**Subject:** DRAFT Revised Response to U.S. EPR Design Certification Application RAI No. 345, FSAR Ch. 9, Question 09.02.01-41  
**Sent Date:** 12/19/2012 5:02:09 PM  
**Received Date:** 12/19/2012 5:02:38 PM  
**From:** WILLIFORD Dennis (AREVA)

**Request for Additional Information No. 345, Question 09.02.01-41**

**U. S. EPR Standard Design Certification**

**Question 09.02.01-41:**

Figure 9.2.5.3—Cross-Section of UHS Tower Basin

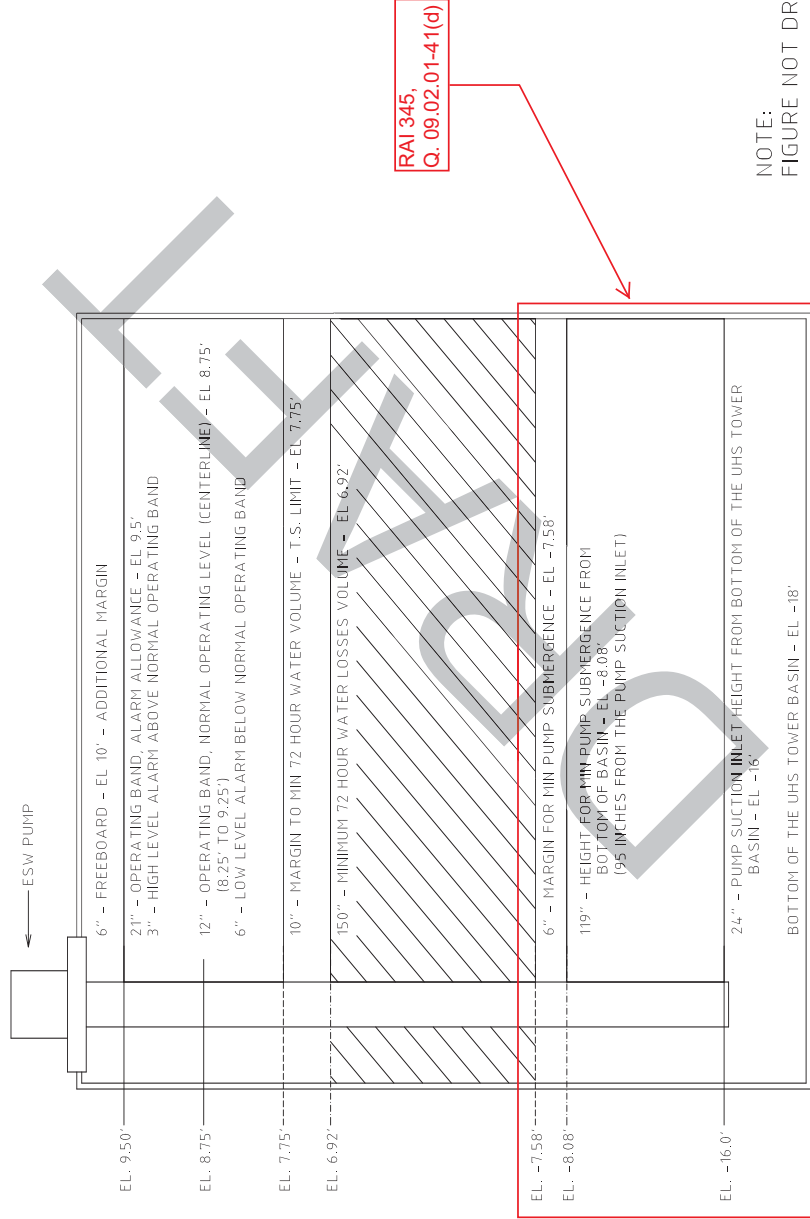
- b. Provide an explanation or clarification of the basin water level at which the ESWS pumps will still be able to perform their intended safety related function since it appears based on Figure 09.02.01-17-1 that at elevation 6.92' (minimum 72 hours water losses volume), the ESWS pumps remain operable at this level. Add to the table NPSH and vortex water level elevation from RAI 9.2.1-08.

- d. The applicant should consider providing Figure 09-02-01-17-1 as a DCD figure since this is an important part of the licensing basis of the ESW pumps defining margins related to NPSH and vortexing, alarms, operating bands, related to the UHS basin.

U.S. EPR FSAR Tier 2, Section 9.2.5, was originally revised to reflect a new figure (Figure 9.2.5-3) which was based on Figure 09.02.01-17-1 that was provided in the Response to RAI 119, Supplement 2, Question 09.02.01-17. U.S. EPR FSAR Tier 2, Section 9.2.5, will be revised to reflect a revised Figure 9.2.5-3—Cross-Section of UHS Tower Basin. A basin tower height with the required margin and allowance is 28 feet from the bottom of the basin. This change has been made to provide increased basin inventory and additional margin for evaporation.

To completely define basin water level, the 24-inch distance between the pump suction inlet and the bottom of the basin will also be clearly identified.
